Subject: Submission for DA2020/0302

Attached is a letter and some supporting documents in relation to DA2020/0302, at 41 Upper Clifford Avenue, Fairlight. Can you please add this to the submissions for the DA.

PROJECT DETAILS
DUAL OCCUPANCY WITH BASEMENT CARPARKING
AND SINGLE DWELLING AT
41 UPPER CLIFFORD AVE
FAIRLIGHT NSW 2094

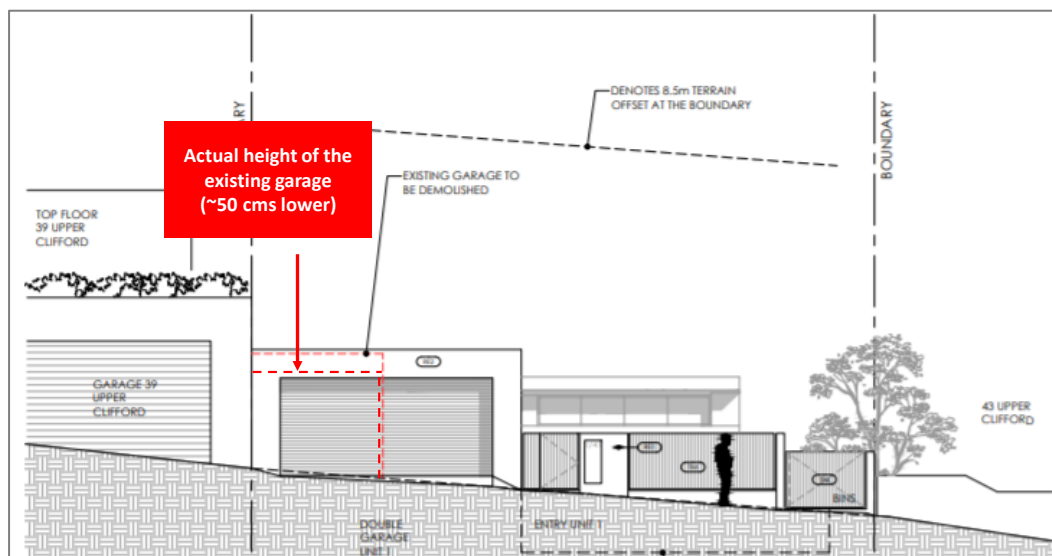
The photo below shows the actual view loss due to a double garage with a roof up to the top of the windows of the garage at 39 UCA, with the entrance hall behind it, and the western half of the living area set back and slightly below this. This is considerably different to the view analysis submitted by the applicant.

The white dotted line represents the normal height of the trees in the middle of UCA, which have not been trimmed for some time. Anything above this line is therefore temporary view loss that would be turned into permanent view loss by the living area of Unit 1.

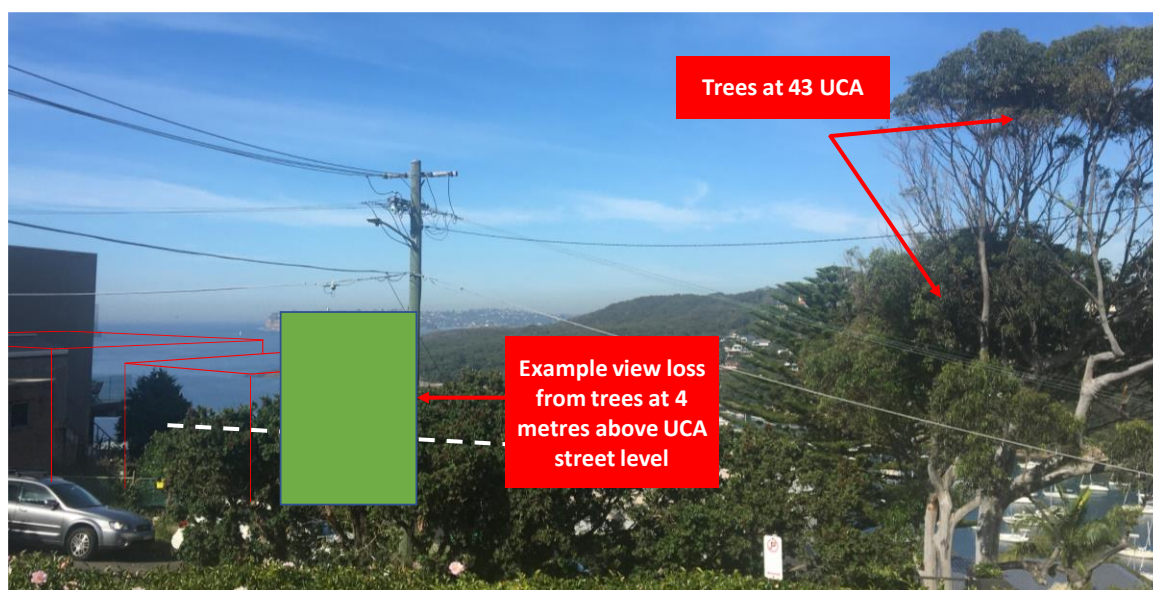
As part of the development the applicant would remove some existing trees and plant some new ones, principally along the western edge of the property. This has the potential to cause significant additional view loss to us. We also believe this would cause significant view loss to the properties at 48 and 50 UCA, as the trees would be in their direct line of sight across the Harbour.

We estimate that trees just four metres above UCA street level would eliminate our view across to South Head. The trees at 43 UCA show the major impact they can have on view loss.

- i. No trees be planted with a maturity height that will exceed the roof height of the unit next to which they are situated; and
 - ii. Given the potential for tree maturity heights to be unpredictable, an obligation be placed on the owners of the units to maintain tree heights as per 4(d)(i).

DRAWING TITLE
ROOF PLAN - SHEET 2
(UNIT 1)
SCALE
1:100
#A3
STATUS
DA
NUMBER
12
REVISION
F

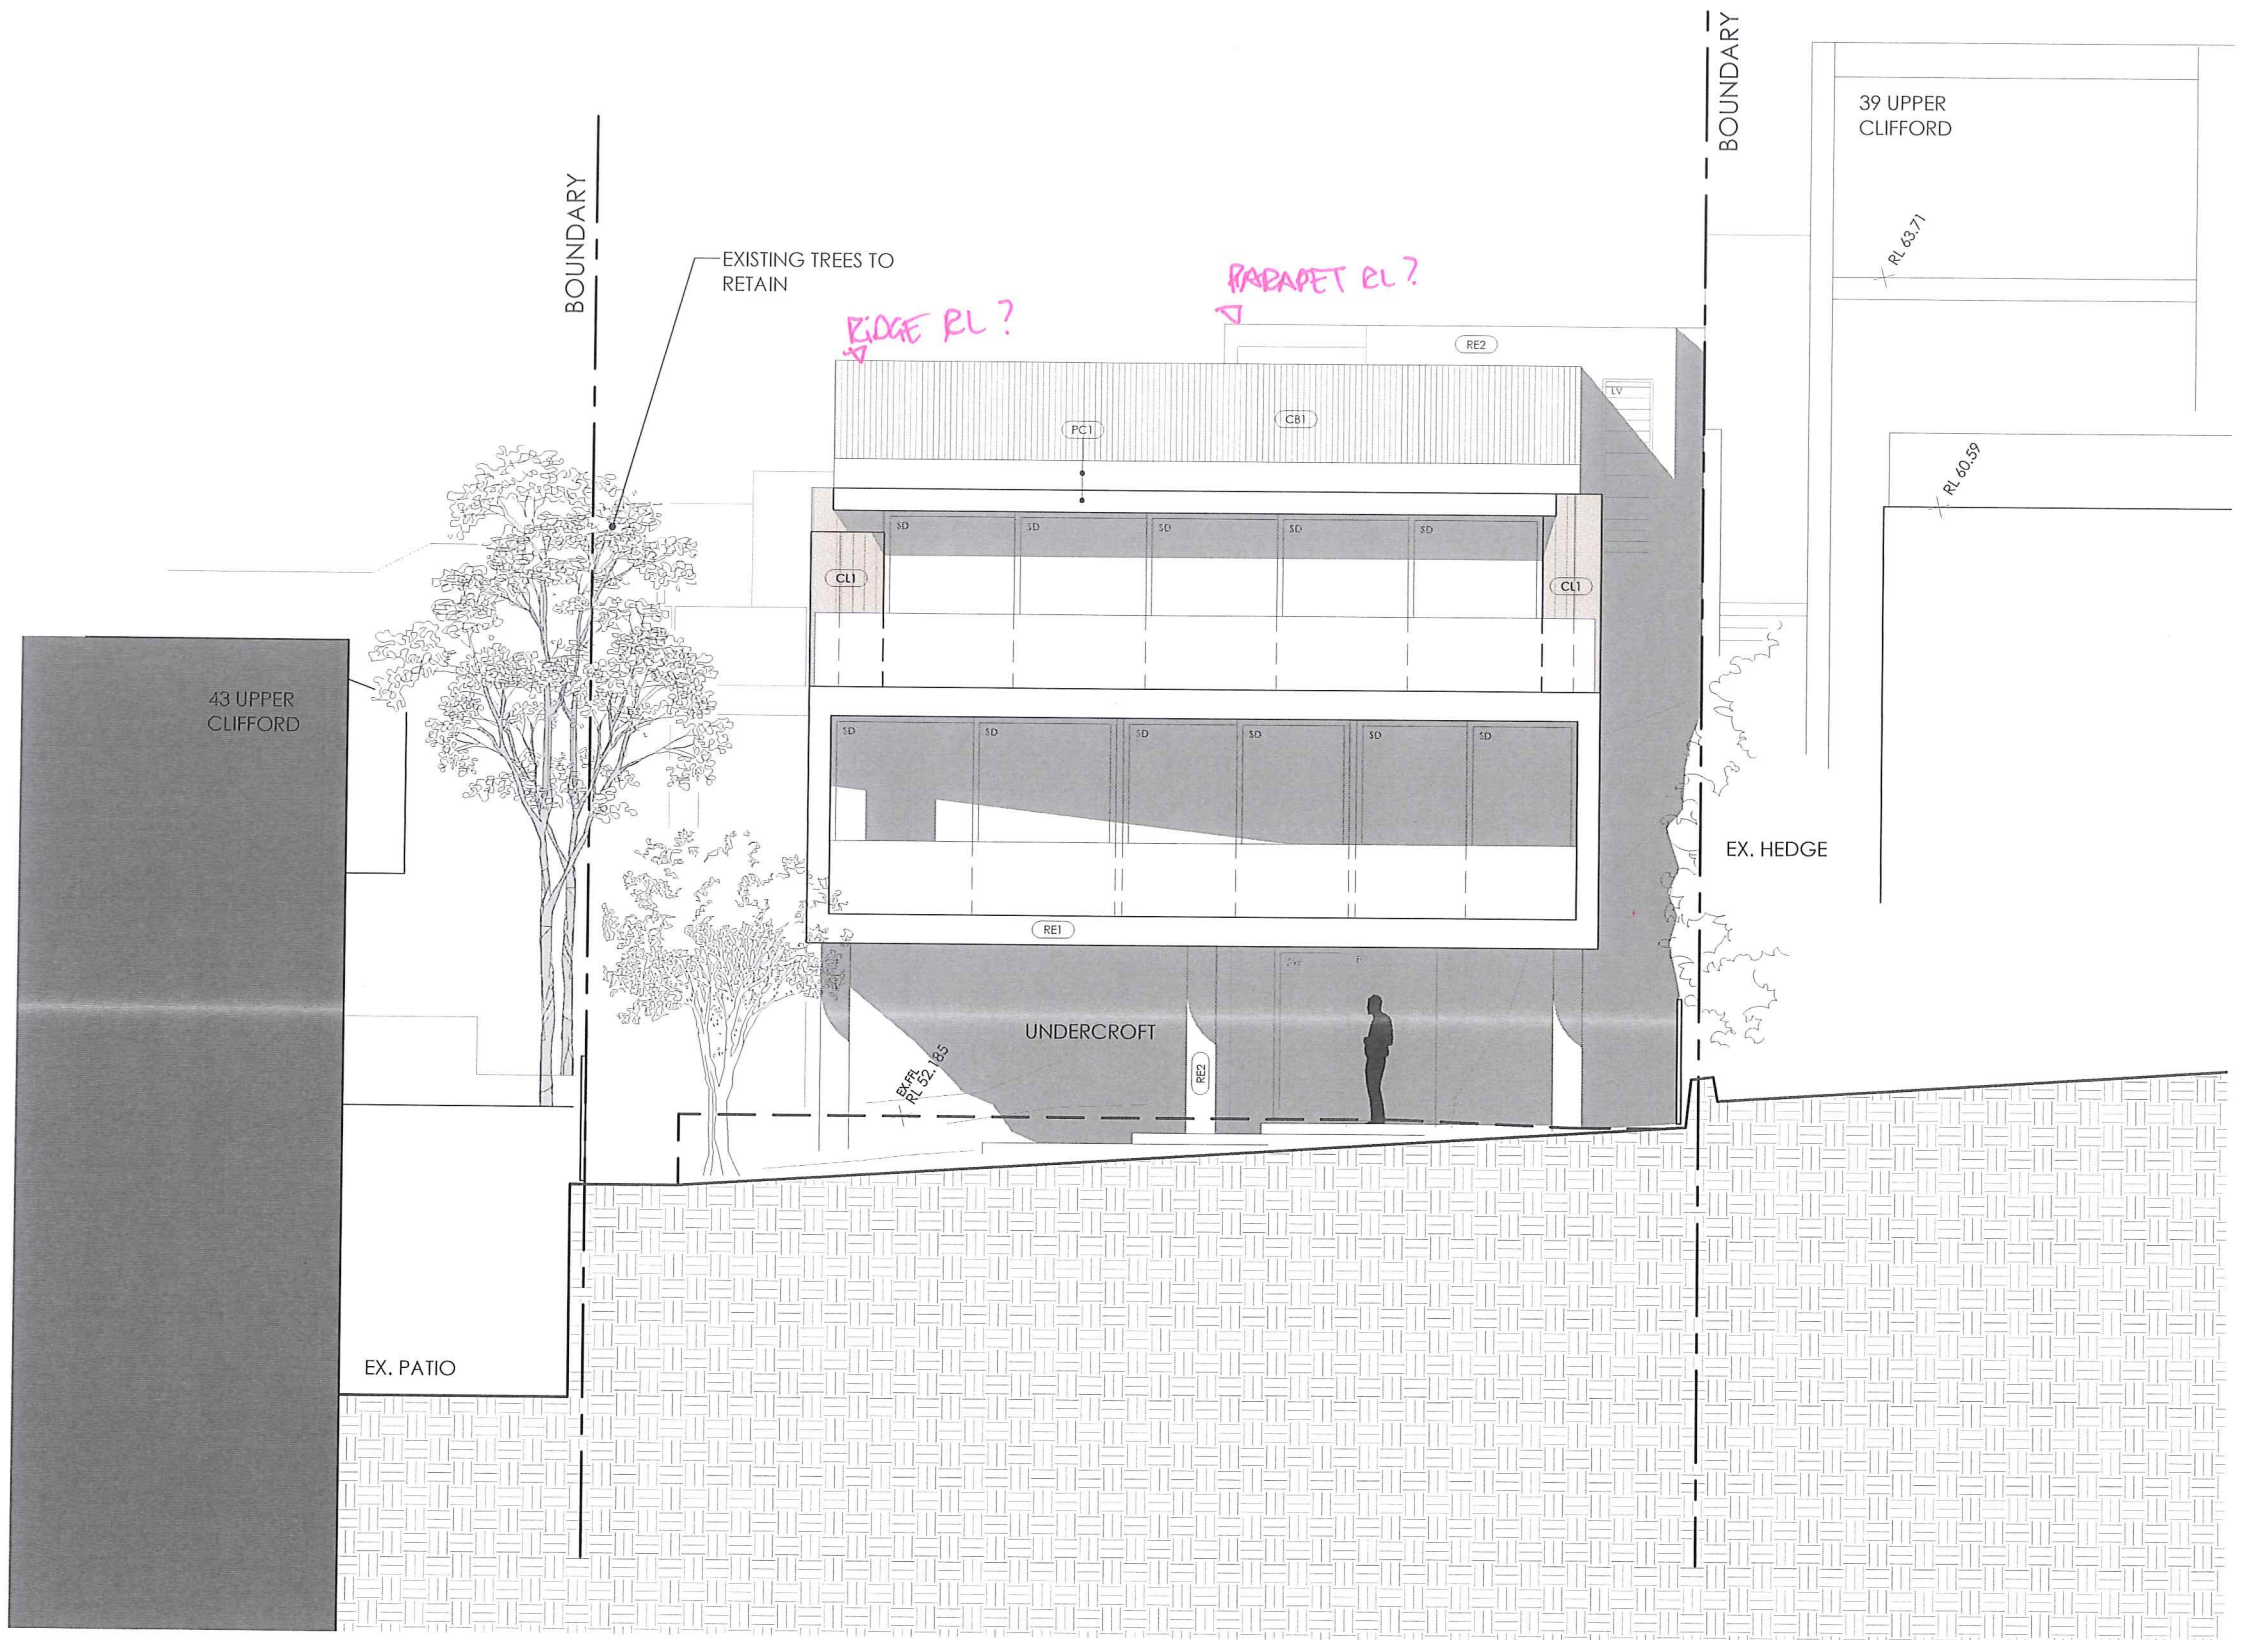
- Floor Plans: Ground RL's are not shown on any plans.
- Roof Plan DA12: The ridge and parapet heights are not shown. This is a major omission that undermines our ability to establish the finished RL's and their impact on our view.

SECTIONAL ELEVATION 6 - EAST

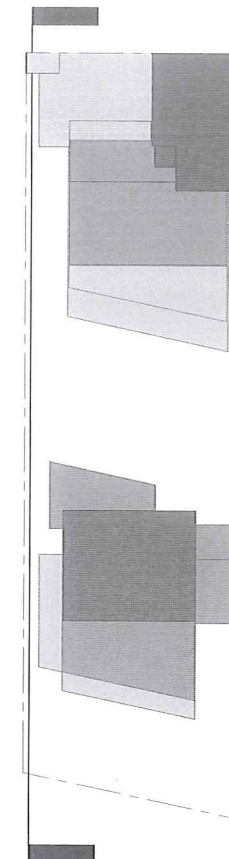
RL PROPOSED?
62.39 existing

SECTION AA

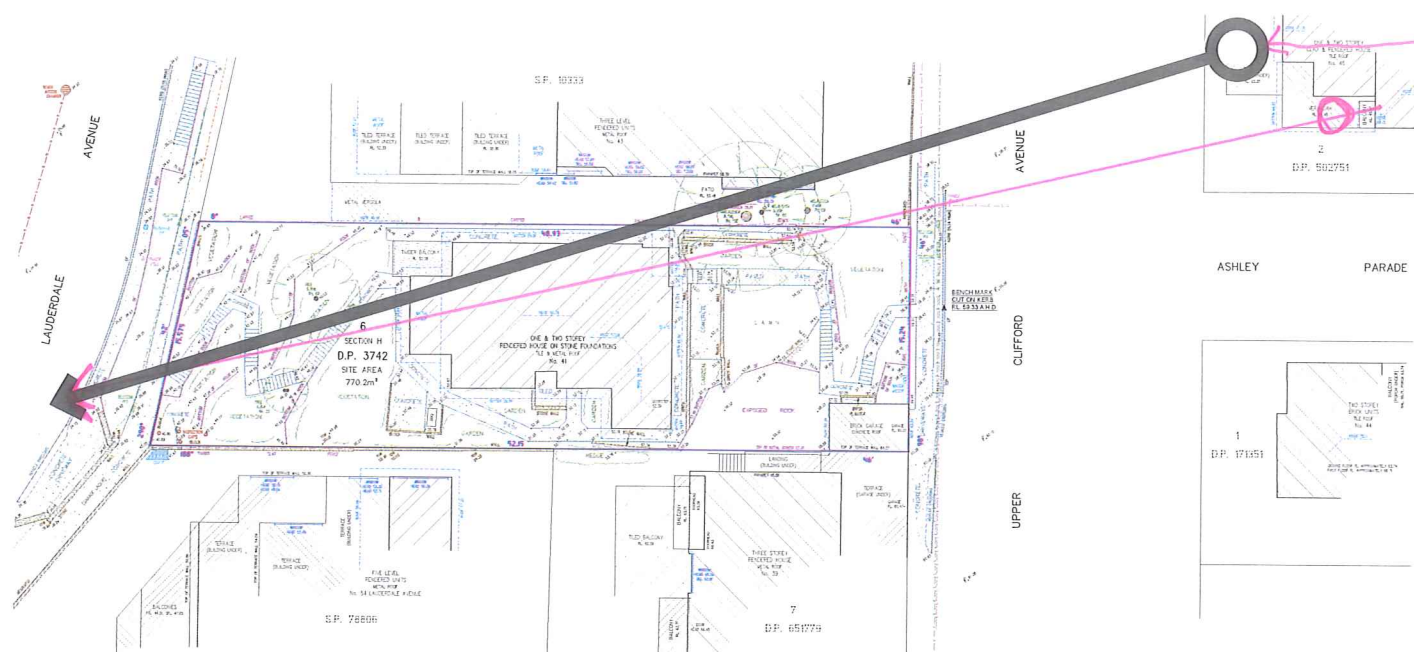
- Section DA23: the excavation does not comply with the 8.5m height limit by 2.5m, as height limit is attached to existing ground levels and not to excavated new ground levels.
